جمهورية مصر العربية
هيئة قناة السويس

تحويل مستندات

- رد على تحويل مستنداتكم بخصوص إستفسارات الشركات في المناقصة رقم ٢٠٢٢/٥/١٥ جلسة الأحد الموافق ٢٠٢٢/٥/١٥ لتوريد وتركيب كاميرات مراقبة لمحطات المياه بمدن القناة الثلاث.

- الرد على الإستفسارات فيما يختص بكاميرات المراقبة وكافة ملحقاتها (ردود أجهزة الشبكة تختص به إدارة الاتصالات ونظم المعلومات والأعمال المدنية والكهربية تختص به إدارة الأشغال).
- رد على شركة جيزة للأنظمة (مرفق ١)
- رد على شركة إنتركوم (مرفق ٢)
- رد على شركة Interact (مرفق ٣)
- رد على شركة Netsync (مرفق ٤)
- رد على شركة Actel (مرفق ٥)
- رد مجمع على الشركات بخصوص الكاميرات (مرفق ٦)

الرد على شركة جيزة

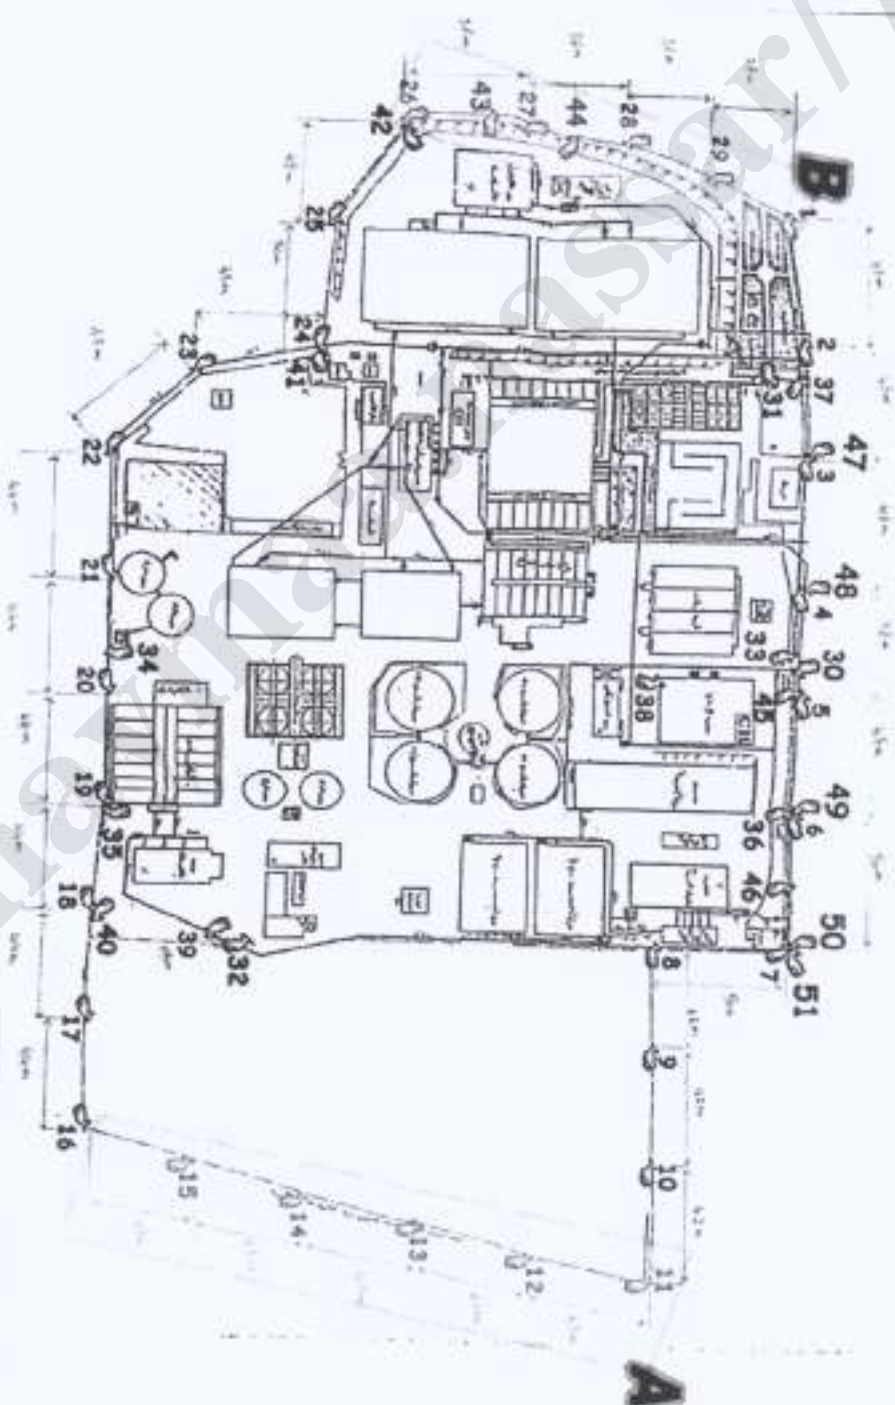
محطة مياه
الإسكندرية
بالنسبة لمنطقة A سيتم
إضافته عند 4 كميرات
لتصبح المسافة بين
الكاميرات 25 متر بين
الضلع

في المنطقة B
سيتم اضافته عند 2
كامير لتصبح المسافة
بين الكاميرات 25 متر
بين الضلع

Fence	1 -> 29
Gates	30, 31, 32
Ways	33, 34, 35, 36
Chlorine station	37, 38, 39
Water house	40 -> 46
Taker	47 -> 51

محطة مياه بوسعيد

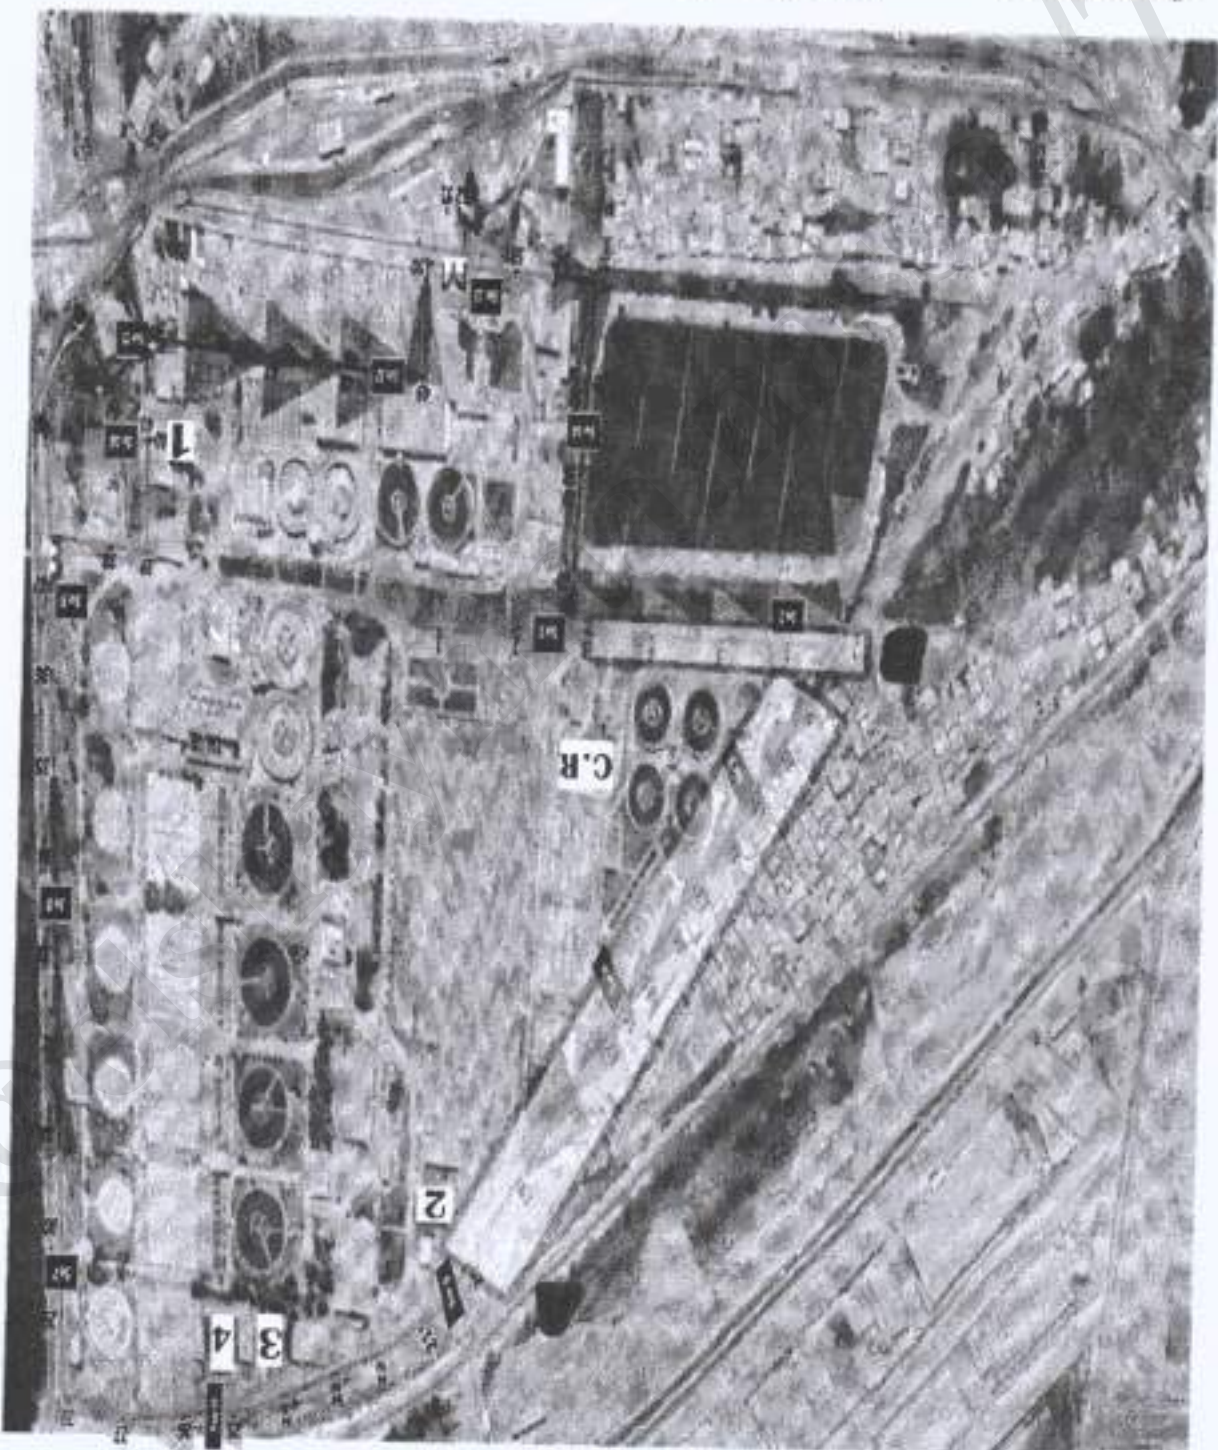
بالنسبة لمنطقة A سيتم
إصلاحه عدد 4 كاميرات
لتصبح المسافة بين
الكاميرات 25 متر بهذا
الضلع

وبالنسبة لمنطقة B
سيتم إصلاحه عدد 4
كاميرات لتصبح
المسافة بين الكاميرات
25 متر بهذا الضلع

محطه قيادة المينوس

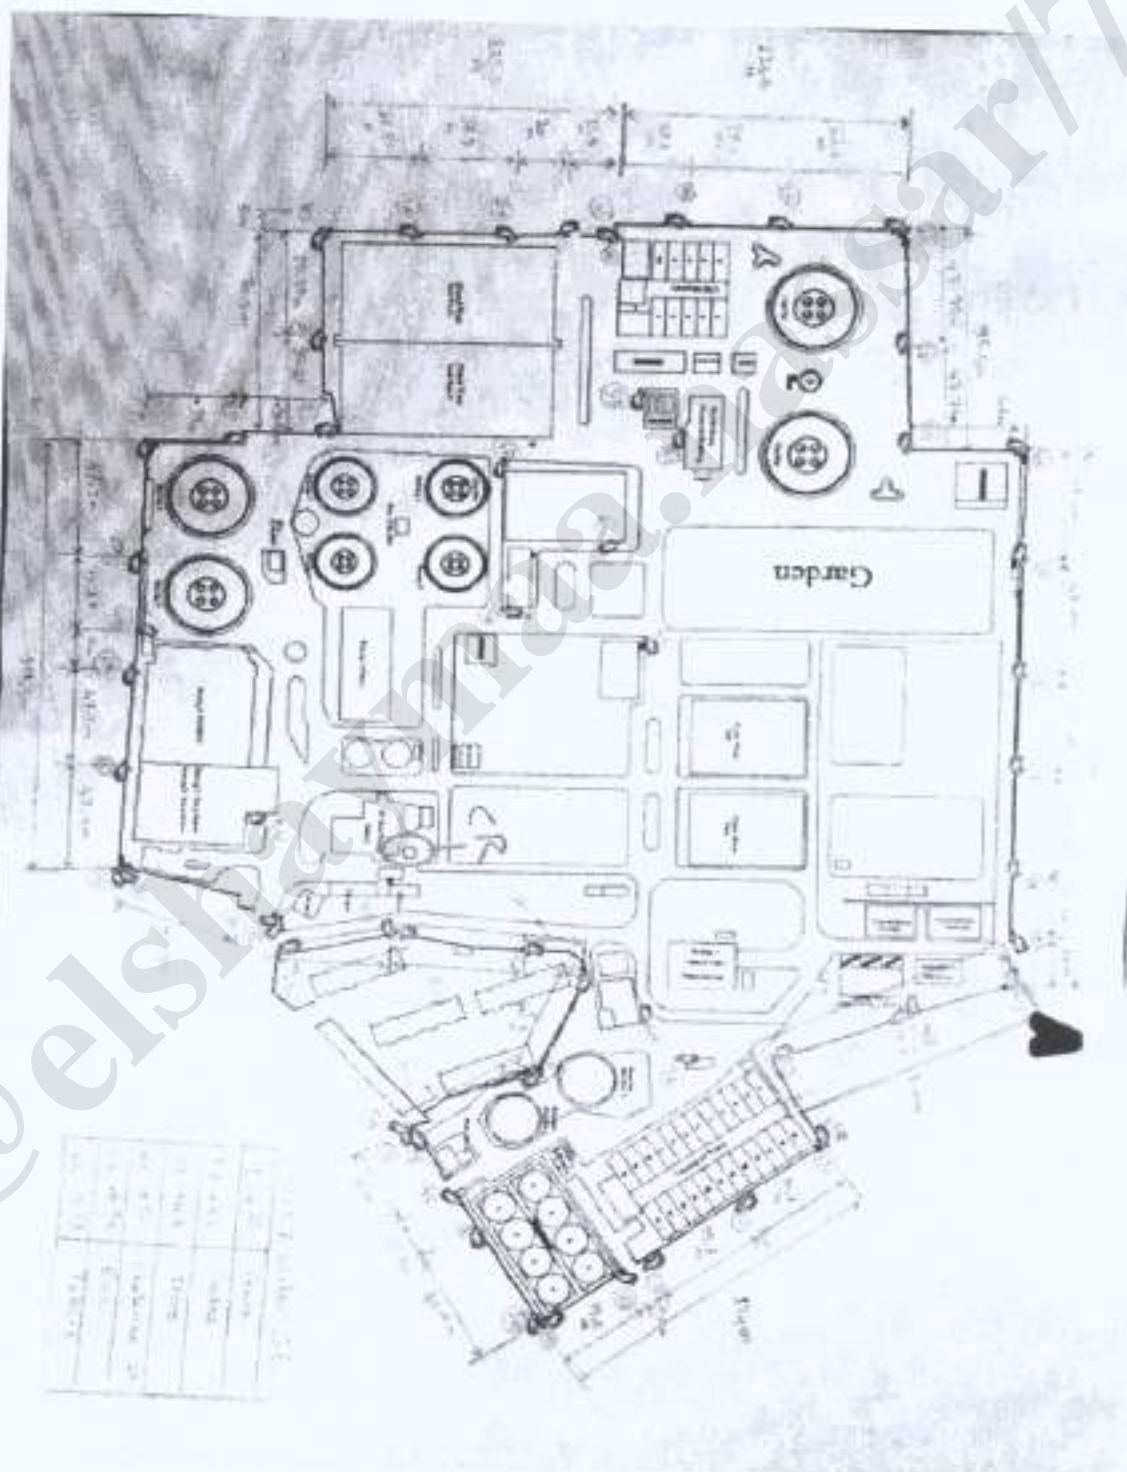
المنطقة A
سليم الصلاح عدد 2
كلير الصلاح
الصداقة بين
الكاميرات 25 متر
بيد الصلاح

الرد على شركة التركوم

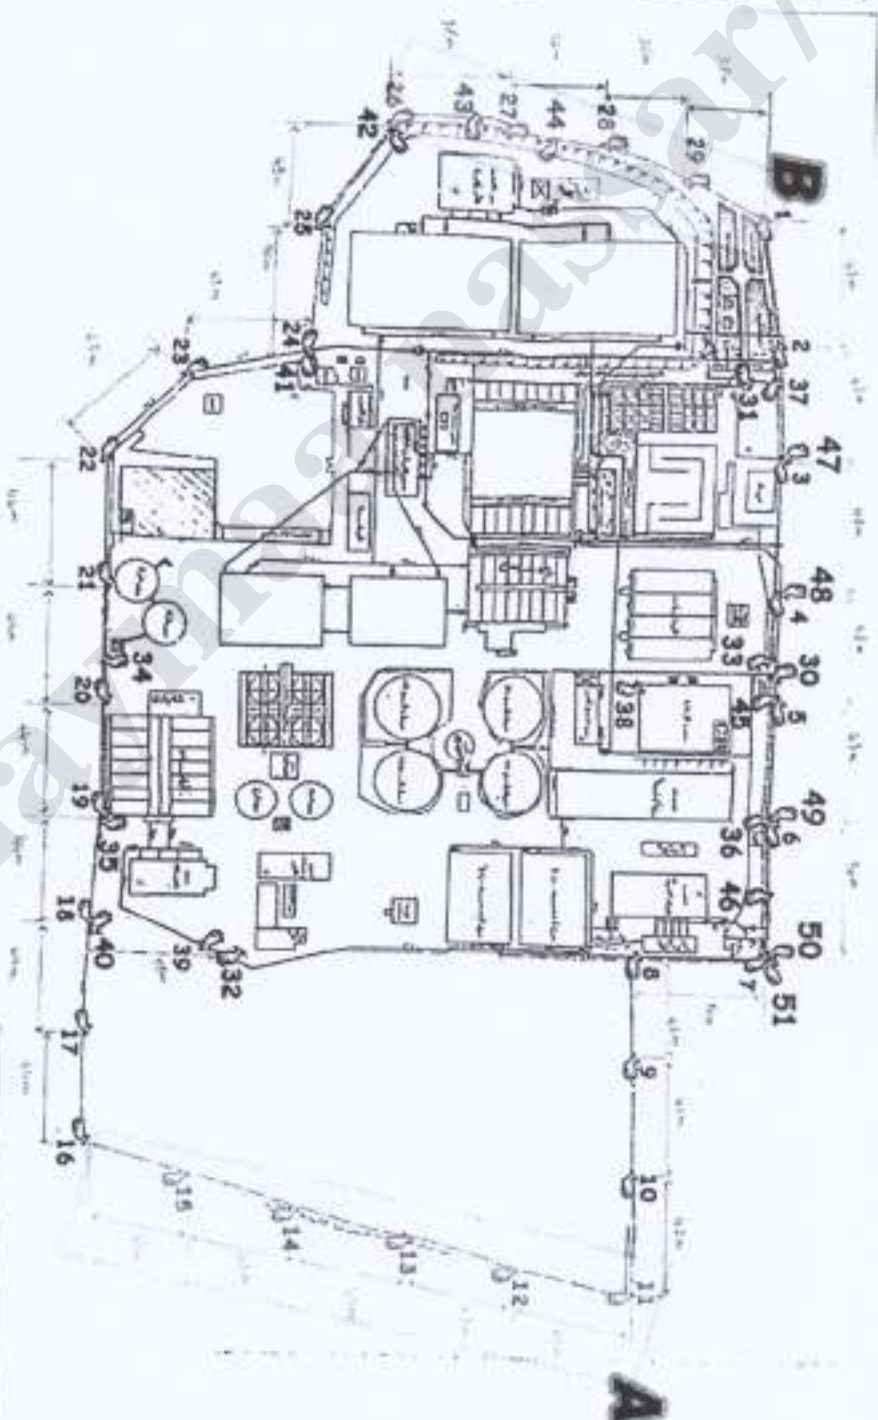
محطة مياه
الإسماعيلية
بالنسبة لمنطقة A سيتم
الضفة عدد 4 كاميرات
لتصحيح المسافة بين
الكاميرات 25 متر بهذا
الضلع

و بالنسبة لمنطقة B
سيتم الضافة عدد 2
كاميرا لتصحيح المسافة
بين الكاميرات 25 متر
بهذا الضلع

Fence	1 -> 29
Gates	30, 31, 32
Ways	33, 34, 35, 36
Chlorine station	37, 38, 39
Ware house	40 -> 46
Taker	47 -> 51

محطة مياه بور سعيد

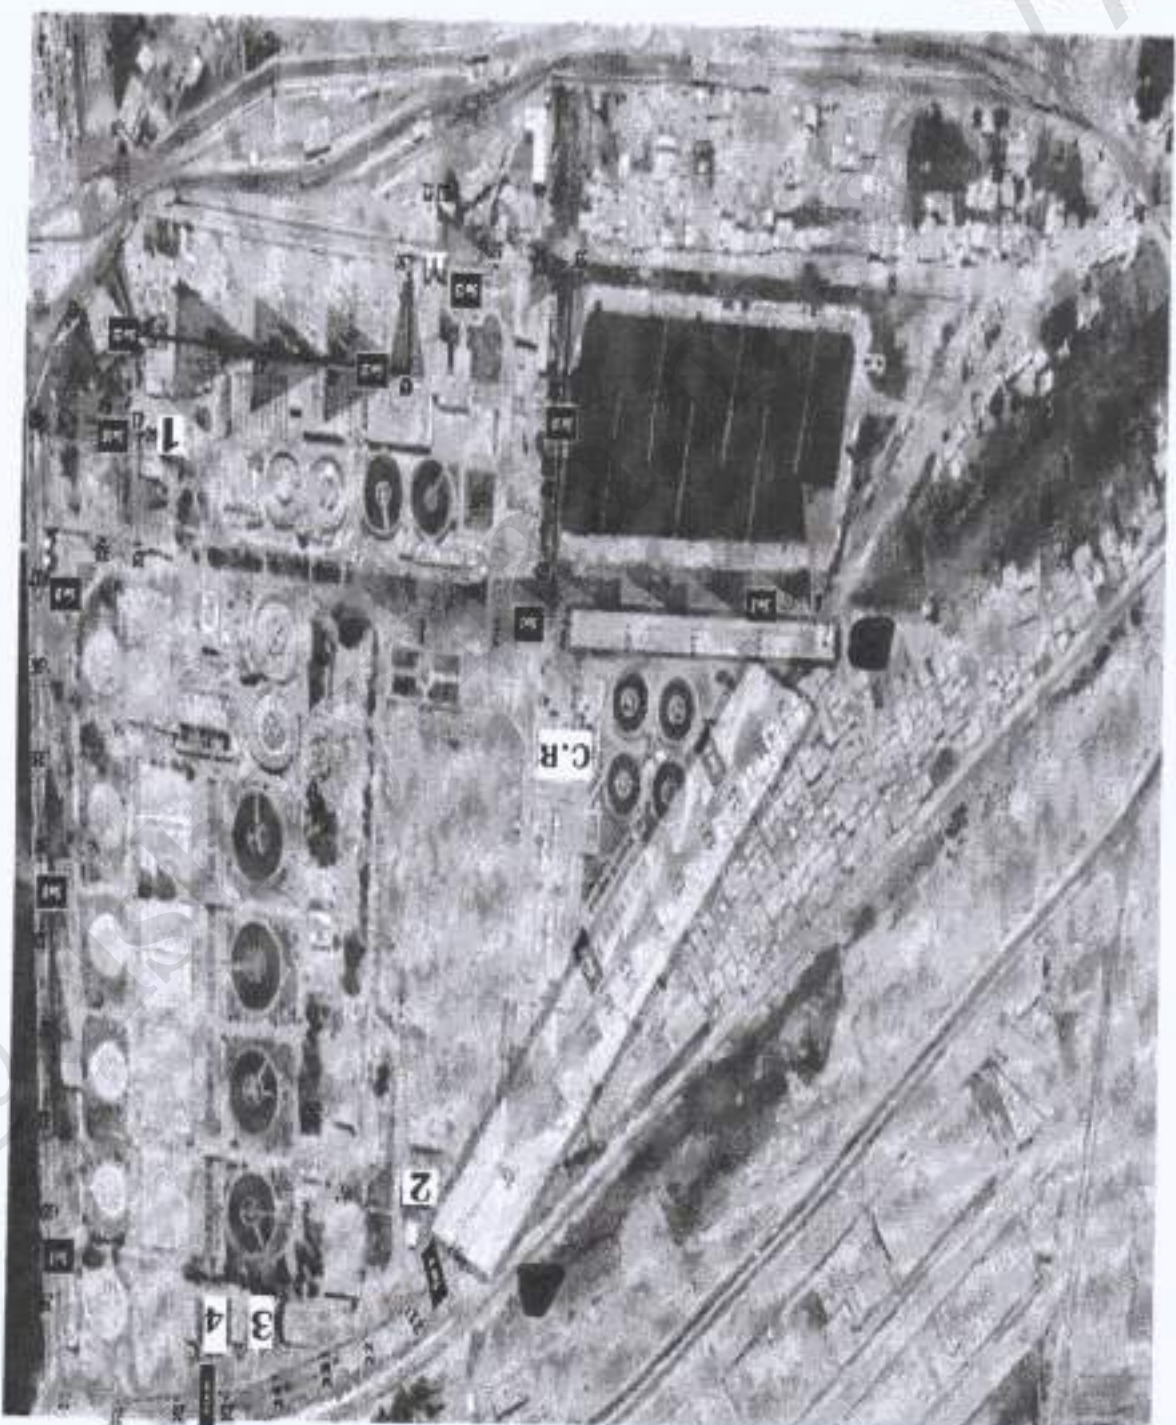
بالنسبة لمنطقة A سيتم
التمدد عند 4 كاميرات
لتصبح المسافة بين
الكاميرات 25 متر بهذا
الضلع

وبالنسبة لمنطقة B
سيتم اضافة عند 4
كاميرات لتصبح
المسافة بين الكاميرات
25 متر بهذا الضلع

محطة مياه
الاسمائية
بالنسبة لمنطقة A سيتم
اضافته عند 4 كميرات
لتصحيح المسافة بين
الكاميرات 25 متر بهذا
الضلع

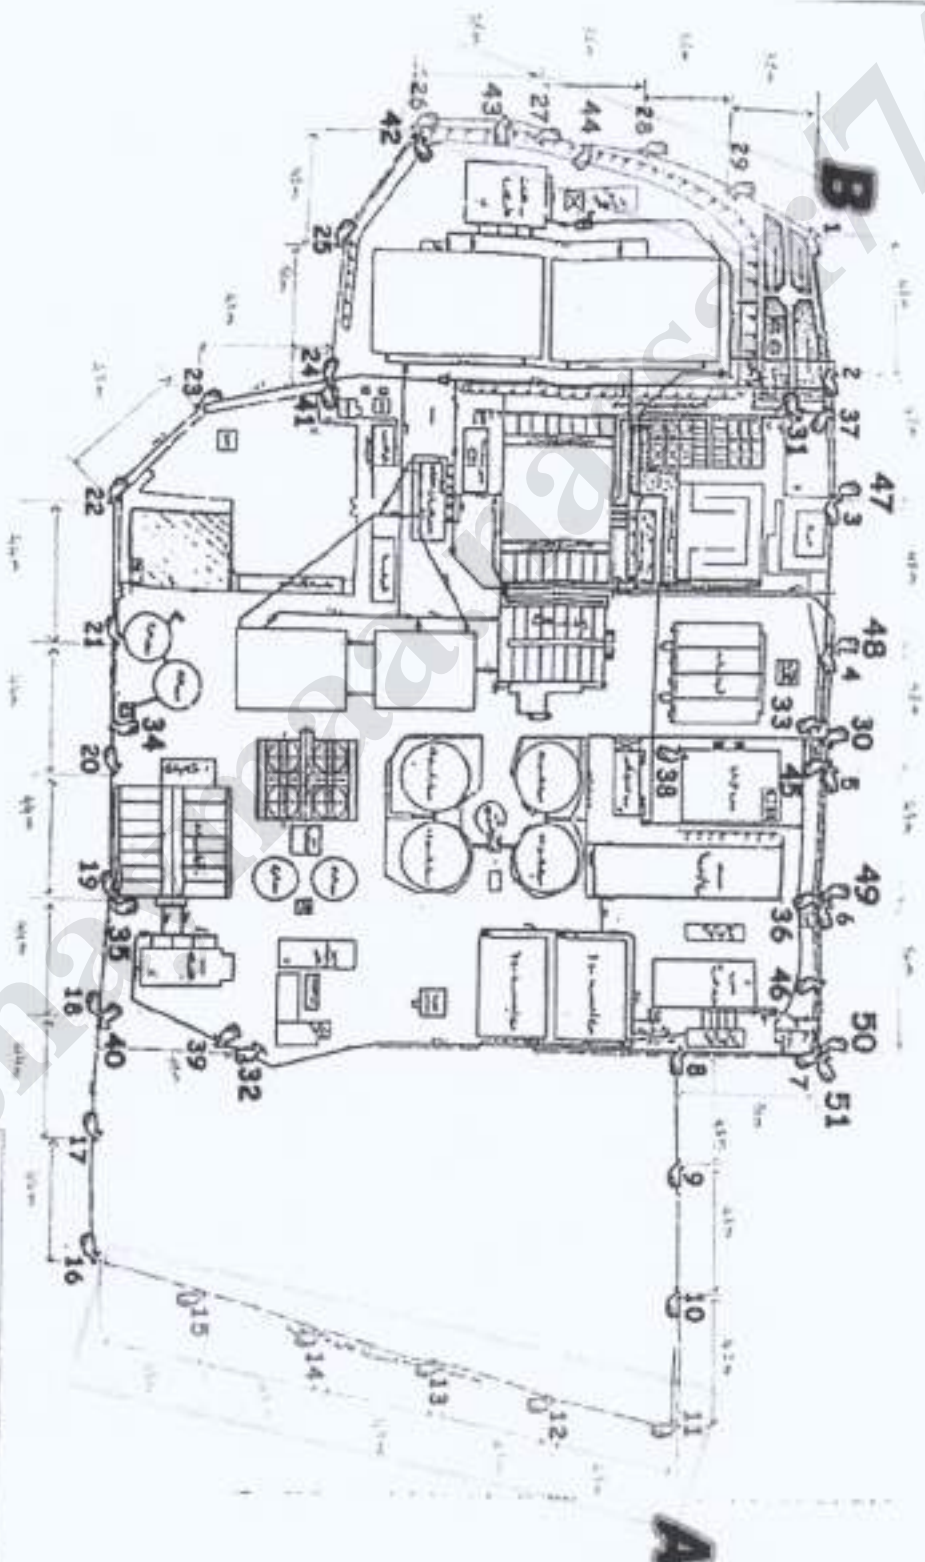
وبالنسبة لمنطقة B
سيتم اضافته عند 2
كامير لتصحيح المسافة
بين الكاميرات 25 متر
بهذا الضلع

Fence	1 -> 29
Gates	30, 31, 32
Ways	33, 34, 35, 36
Chlorine station	37, 38, 39
Ware house	40 -> 46
Taker	47 -> 51

مدرسة ميقات السويسي

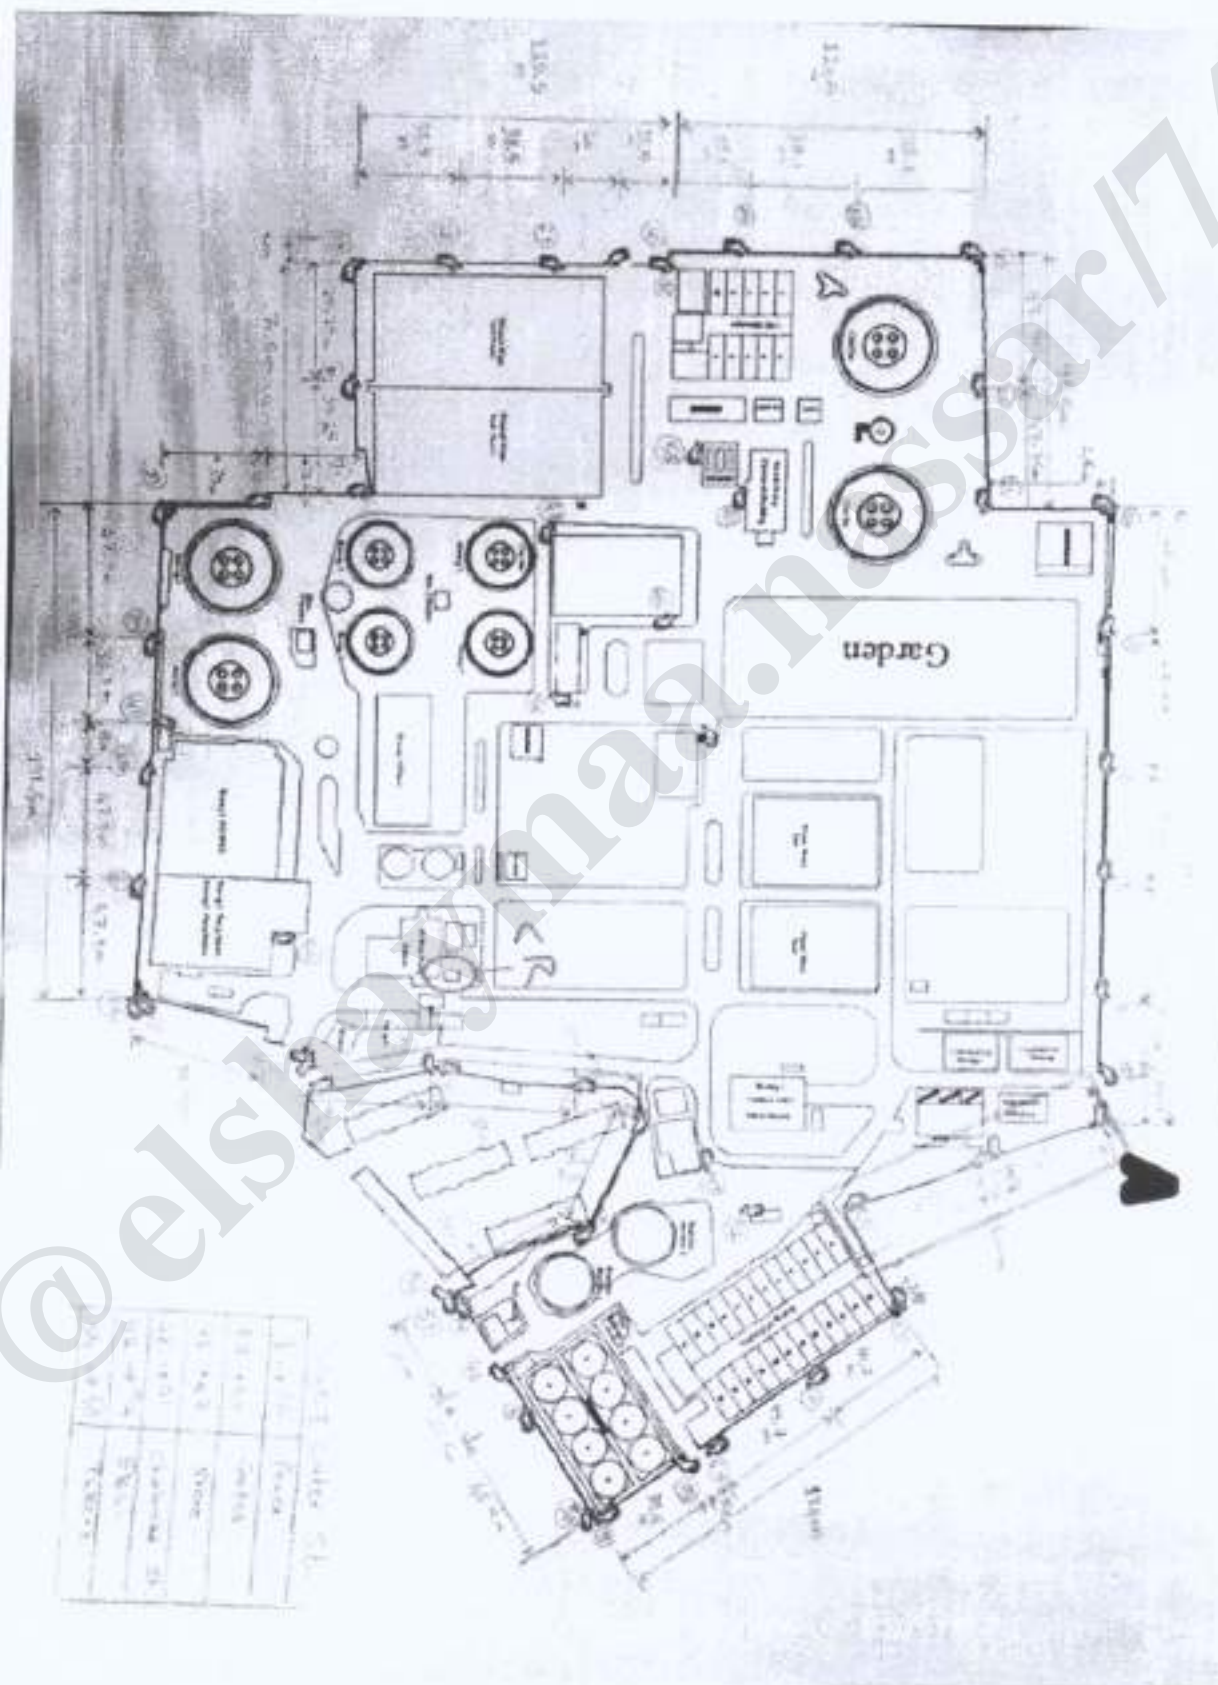
بالنسبة لمعادلة A
 سيتم إضافة عدد 2
 كما هو التصحيح
 المعادلة بين
 الكاميرات 25 متر
 بهذا الصنيع
